# STUDIOHOUSE ON SIXTH

2108-12 NORTH 6TH STREET

## 2108 North 6th Street

Thank you for the comments and suggestions on our project, 2108 North 6th Street (ZP-2022-010839)  
Please find this letter as a response summary.

CITY OF PHILADELPHIA DEPARTMENT OF STREETS			
BIKE RACK PLACEMENT			
DATE	11/04/14	SHEET 1 OF 1	DRAWING NO.
REVISED	3/01/15		FZ0101C
APPROVED: V.L.F.

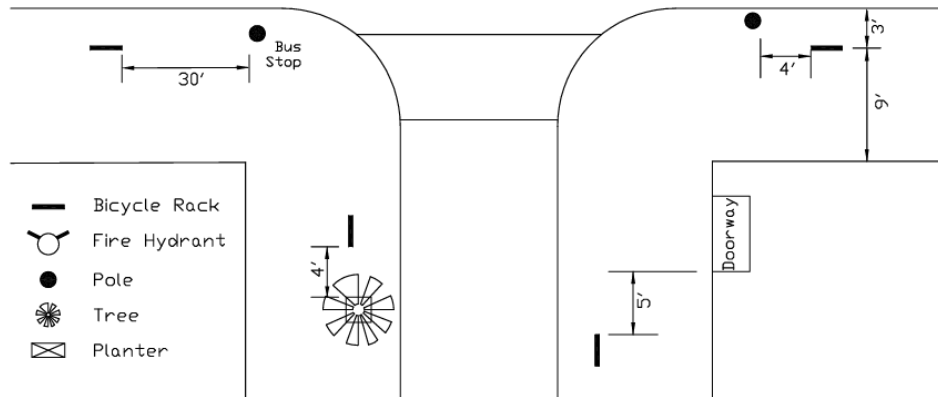
3. Please include the ground floor plan showing the surroundings for the committee to better understand the context. Staff appreciates the addition of bike parking on the ground floor, but additional spaces are necessary to provide greater accessibility.

4. The site plan includes non-compliant bike racks in the furnishing zone, please update the site plan to include a minimum of 4 U bike racks.

Thank you for the comment. The proposed rolling rack was removed and 3 additional U-bike racks were added along North 6th Street per Staff Comments.

New 10 Type 1A bike spaces were added to the first-floor garage. The rolling rack was removed and per "FZ0101C" Bike Rack placement of Streets Guidelines, We were able to add 3 U bike racks.
